Planning & Zoning Board

Thursday, May 2, 2024

**MINUTES REGULAR MEETING
REYNOLDSBURG PLANNING & ZONING BOARD
April 4, 2024**

SPRING HILL FARM SECTION 6 PART A

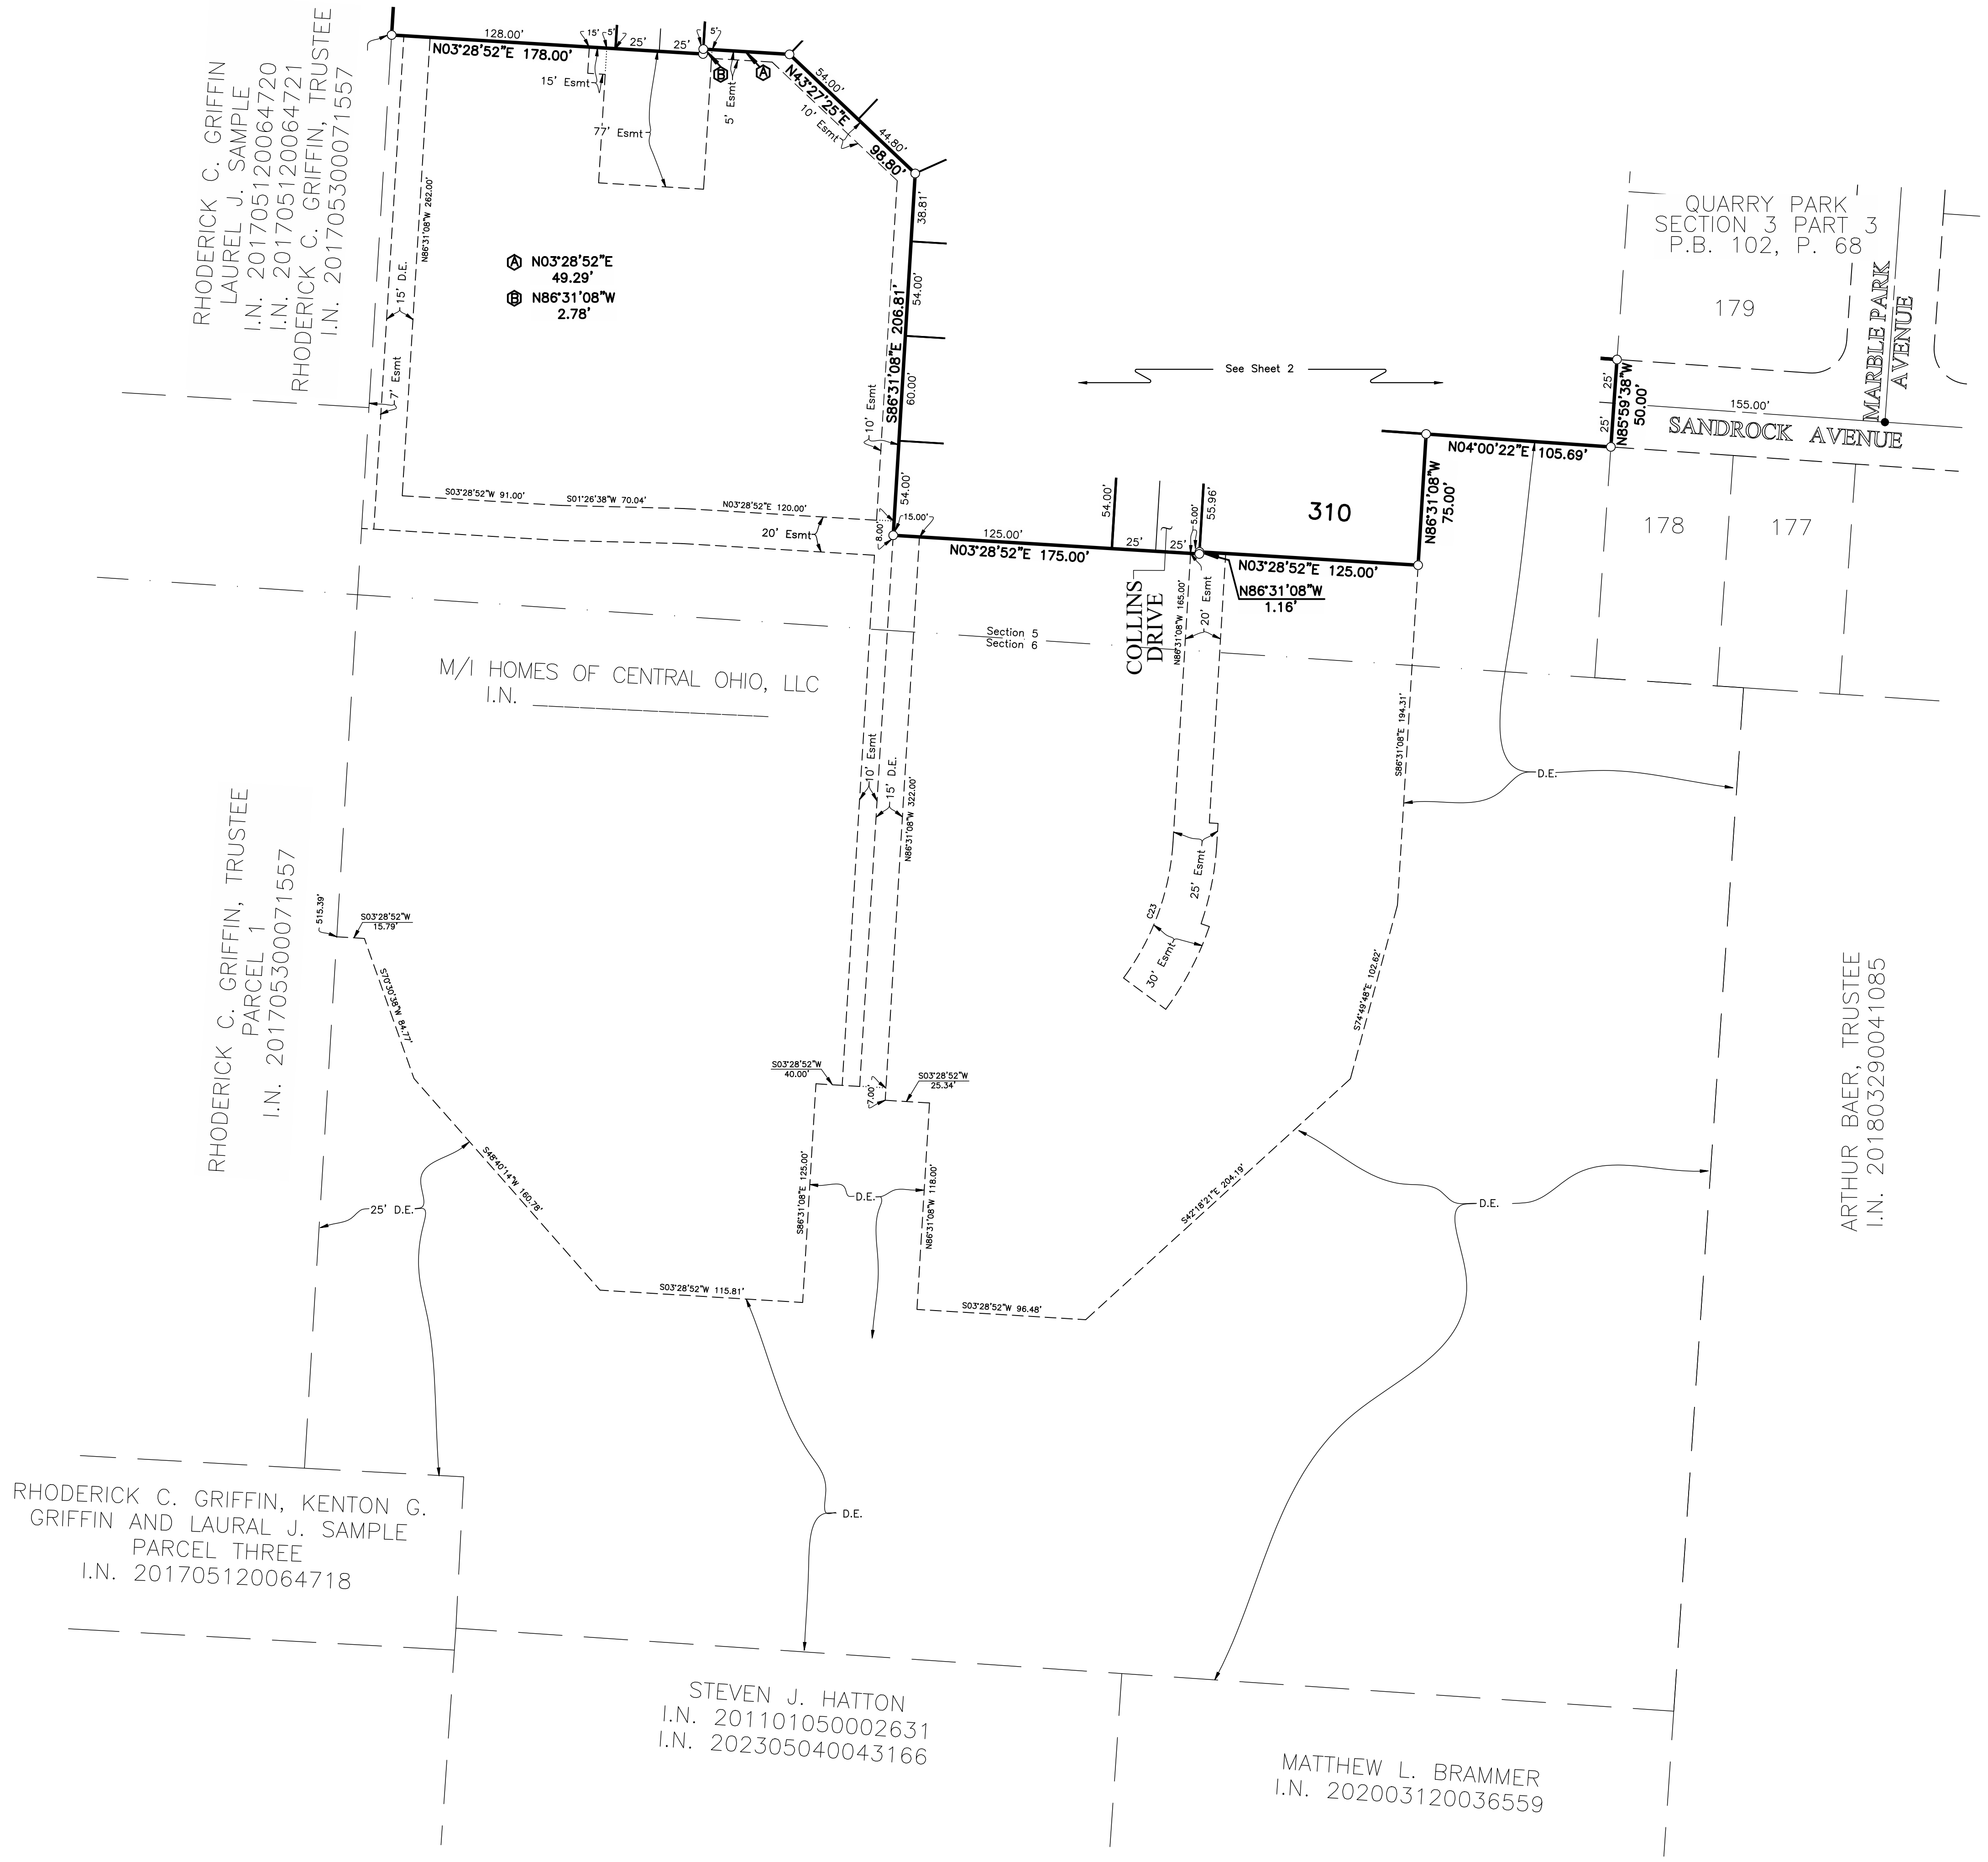
- a. Sheet 1 of 3: There is the instrument reference that is a 2023XXXXXX placeholder. Should this be a 2024 prefix and can this number be filled in at this time or does it need to have a blank line for a remainder parcel?
- b. Sheet 2 of 3: The street drawings state Reserve "M" shown between lots 301 and 302 as Reserve "N". Please make sure these both match.
- c. Sheet 3 of 3: For reference purposes, label the centerline of Collins Drive on the north side of the site.
- d. Sheet 3 of 3: The adjoining parcel for Steve Hatton has changed ownership with new instrument numbers. Please ensure all adjoining names are current per the Franklin County auditor and recorder's website.

- a. Recommend final plat approval of Spring Hill Subdivision Section 6 Part A, with the following conditions:
 - i. That sheet 1 of 3 be revised as noted in the above project review (2.c-e) to the approval of City staff.
 - ii. That the plat be revised as noted in the above engineering review (3.a-d) to the approval of City Staff.
 - iii. That the plat is revised to city staff's satisfaction before going to City Council.

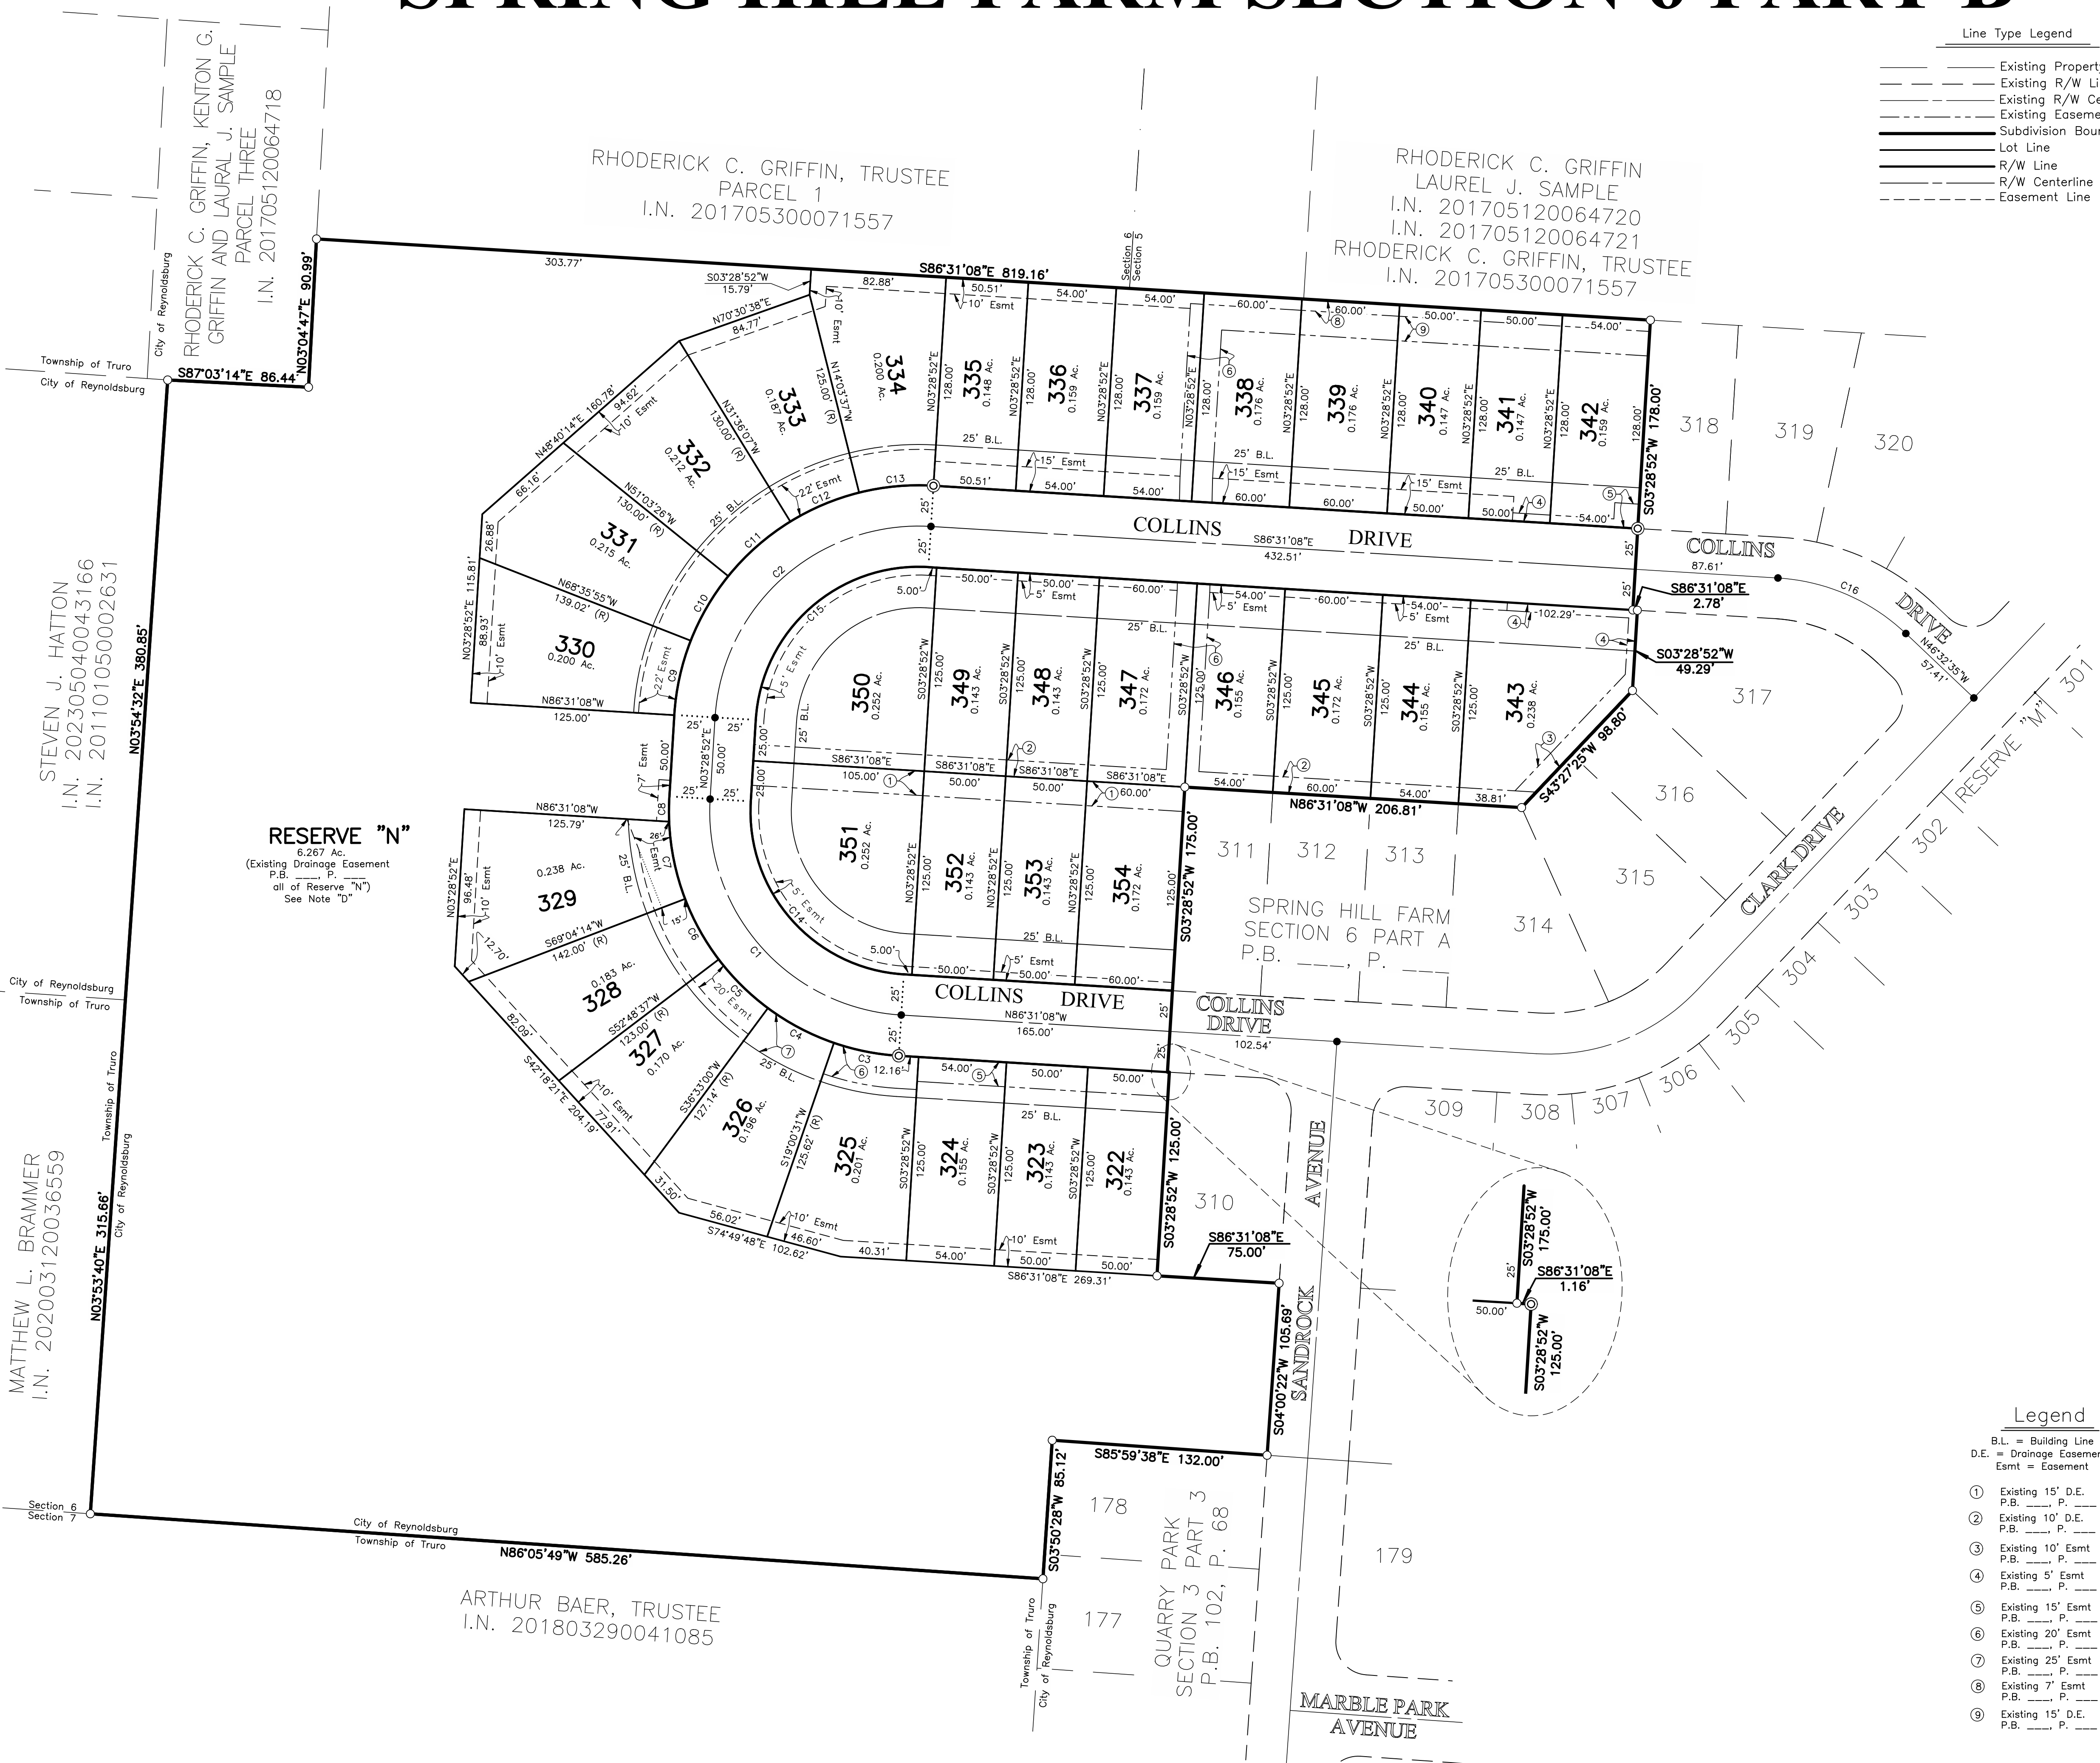
- a. Sheet 1 of 2: There is the instrument reference that is a 2023XXXXXX placeholder. Should this be a 2024 prefix and can this number be filled in at this time or does it need to have a blank line for a remainder parcel?
- b. Sheet 2 of 2: The adjoining parcel for the Steve Hatton has changed name with new instrument numbers. Please ensure all adjoining names are current per the Franklin County auditor and recorder's website.
- c. Sheet 2 of 2: Reserve "N" does not match what is shown on the street plans. This is labeled as Reserve "M" on the recently reviewed street plans.
- d. Sheet 2 of 2: The sum of the various acreage breakdowns is off by 0.004 acres from the total acreage listed. Please advise on the difference in areas or update the summary accordingly.

- a. Recommend final plat approval of Spring Hill Subdivision Section 6 Part B, with the following conditions:
 - i. That sheet 1 of 3 be revised as noted in the above zoning review (2.c-e) to the approval of City staff.
 - ii. That the plat be revised as noted in the above engineering review (3.a-d) to the approval of City Staff.
 - iii. That the plat is revised to city staff's satisfaction before going to City Council.
